UNITED STATES
NUCLEAR REGULATORY COMMISSION
ADVISORY COMMITTEE ON REACTOR SAFEGUARDS
WASHINGTON, D.C. 20555-0001

SUBJECT: SUMMARY REPORT - 472ND MEETING OF THE ADVISORY
COMMITTEE ON REACTOR SAFEGUARDS, ON MAY 11-13,
2000, AND OTHER RELATED ACTIVITIES OF THE COMMITTEE

Figure 1. Adequacy Demonstration Process

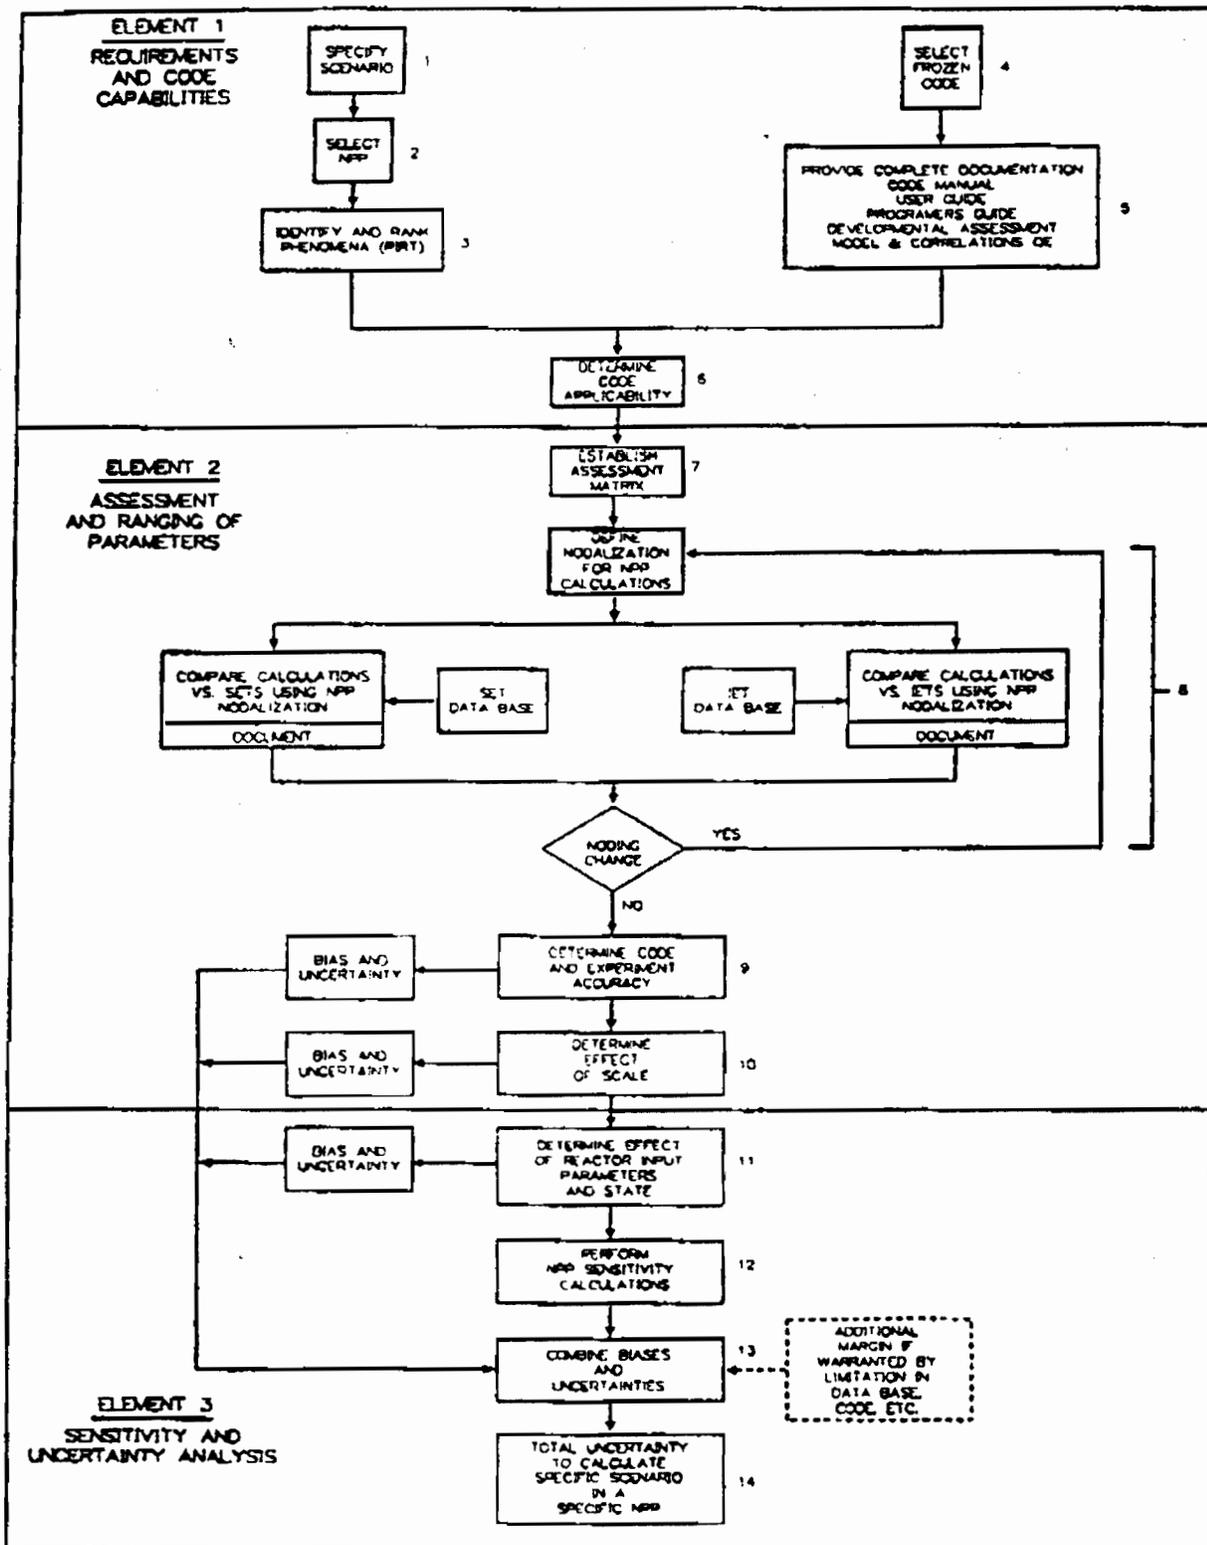
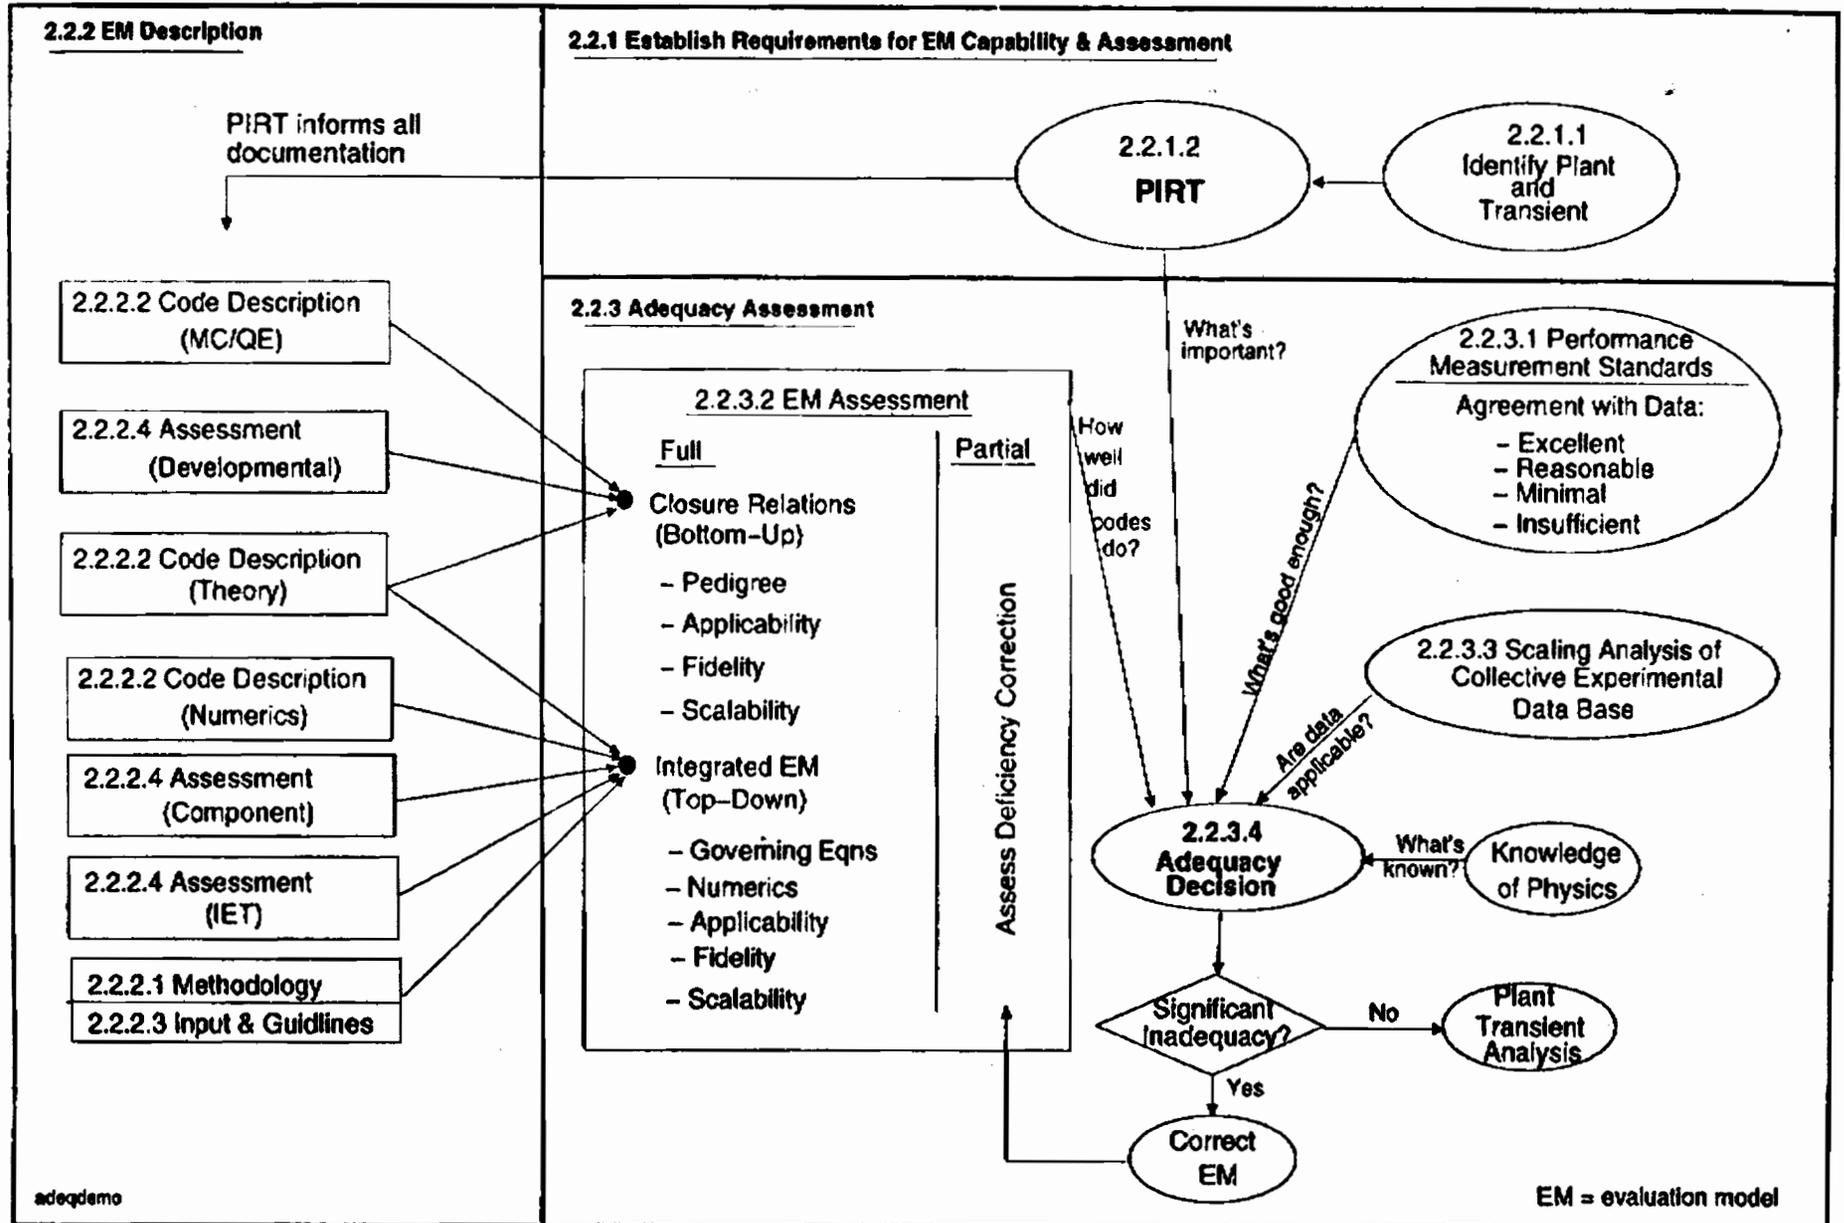
The RG and SRP documents we reviewed and discussed at the T-H Subcommittee meetings refer to CSAU, but in fact, bear little or no resemblance to it. For example, Figure 1 in Attachment III and Figure I in Attachment IV are the flow and activity charts – the first for CSAU, and the second for the RG-DG-1096. It can be seen that the structure and “road map” of CSAU are well defined, simple and easy to follow by the applicant and regulator. The opposite is true of Figure I of the RG. It is far too convoluted to serve as any sort of road map.

Consider first the code assessment. One of the most significant conclusions drawn by the TPG was the imperative to perform assessment and plant calculations using identical nodalization. It is for this specific reason that nodalization is highlighted in Step 8 of CSAU. You will note that nodalization does not appear at all in Figure 1 of the RG.

Next, consider uncertainties. You will note that CSAU identifies and deals with three uncertainties, independent of each other. They are highlighted in Steps 9, 10 and 11. Step 9 accounts for uncertainties from code assessment calculation, Step 10 accounts for the effects of scale distortion, and Step 11 considers uncertainties associated with reactor parameters. Again, you can see that Figure 1 of the RG-DG-1096 shows no activity associated with uncertainty. Indeed, the word "uncertainty" does not appear anywhere in that figure.

In view of the forgoing, I fail to comprehend how Figure 1 of the RG could be titled "Adequacy Demonstration Process." To my way of thinking, this figure demonstrates only technical incompetence, absence of vision and lack of planning on the part of management. It also represents ten wasted years, during which the CSAU methodology could have been tested and improved. Had this been done, NRC could have entered the PDE armed with a robust methodology. As it is, NRC has an RG and SRP which are frivolous at best, and are vulnerable to abuse by unscrupulous persons or misuse by inexperienced ones.
